**STAFF REPORT:** NOVEMBER 8, 2023 REGULAR MEETING      **PREPARED BY:** T. BOSCARINO  
**APPLICATION NUMBER:** HDC2023-00071  
**ADDRESS:** 1200 LONGFELLOW  
**HISTORIC DISTRICT:** BOSTON-EDISON  
**APPLICANT/OWNER:** IVAN ALEXANDER  
**DATE OF PROVISIONALLY COMPLETE APPLICATION:** OCTOBER 15, 2023  
**DATE OF STAFF SITE VISIT:** OCTOBER 21, 2023

**SCOPE:** ERECT GLASS DOME STRUCTURE AND FENCE (REVISION TO PREVIOUSLY APPROVED APPLICATION)

Site plan from application documents with proposed dome shown in orange; red lines added by staff to show approximate location of proposed fence.

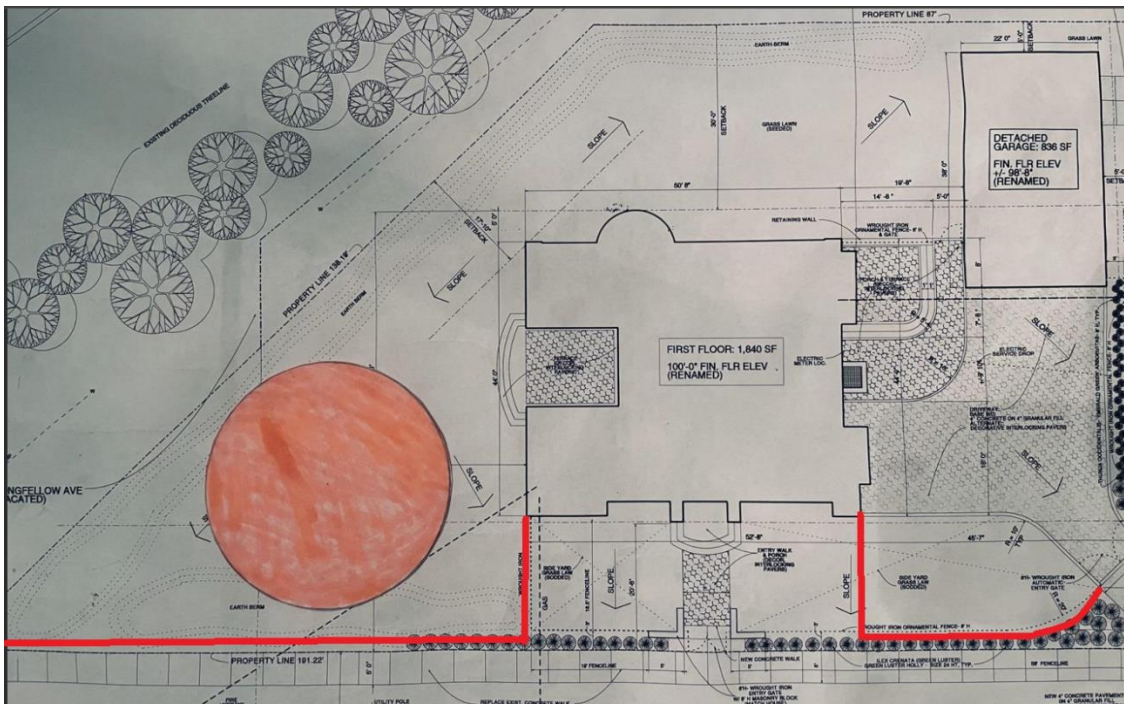
The applicant proposes to erect a 19’ geodesic dome with aluminum structure and glass panels. The structure would be located partially in the front yard. Also proposed is a 6’ fence of wood, possibly with brick or stucco posts.

- In addition to the architectural incompatibility, the proposed dome is also partially located in the front yard, interrupting a character-defining open space and disrupting the wall of continuity that is “created by the buildings with their uniform setbacks within the blocks” and “generally consistent within each block or area” as noted in the Elements of Design quoted above.

- Further, the proposed dome location is partially within the former Longfellow right-of-way. Even if partially concealed behind a fence, it would be readily visible along the length of Longfellow to the east, and would further the disruption of the traditional street grid that began with the construction of the expressway.

- As noted above, staff opinion has previously been provided that a front fence should generally be located at the plane of the building’s front façade, consistent with the *Fence and Hedge Guidelines*. Open, unfenced front lawns are characteristic of Boston-Edison; therefore, a fence at or near the sidewalk would not be compatible with its environment (Standard #9).

- The fence is located much further forward from the plane of the front façade than is found in other houses in Boston-Edison.

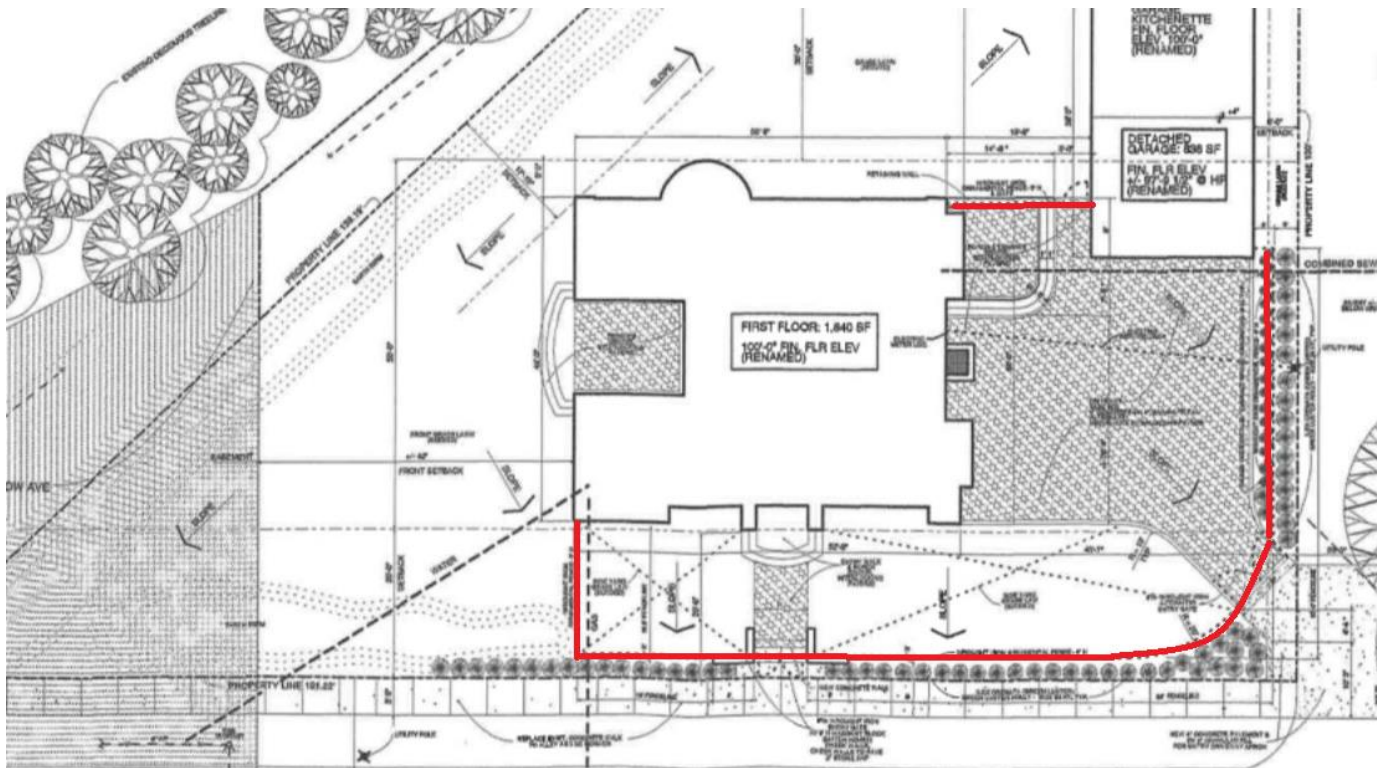
- The proposed dome is largely incompatible with the architecture of the Boston-Edison Historic District (see “Issues,” below). However, buildings, structures, or additions of contrasting architectural styles are not always inappropriate, if sufficiently limited in scale and situated in a manner that does not interrupt a character-defining open space and does not distract from the architecture of the primary building or the district as a whole. Alternatively, a domed structure could potentially be appropriate as an integrated part or addition of an otherwise compatible building. Again, this would most likely be as a rear addition that did not visually compete with or distract from the architecture of the district. Given the larger-than-typical

size of the subject property, it may be possible to include such a structure or addition in an appropriate manner, especially if the design of the previously approved house and garage were altered.

- The Secretary of the Interior’s Standards, namely Standard #9, require that new construction “shall be differentiated from the old and shall be compatible with the massing, size, scale, and architectural features to protect the historic integrity of the property and its environment.” Although the proposed dome clearly satisfies the differentiation requirement, it is not compatible, especially in terms of massing and architectural features. The proposed structure introduces the massing of a dome into an environment where buildings of frame or masonry construction—with the associated planar, right-angled façade elements—are universal. Buildings are topped with hip or gable roofs rather than round surfaces. The various Elements of Design quoted above reference a design context in which the proposed structure is out of place, and therefore not “compatible” with the “environment” as required by Standard #9.
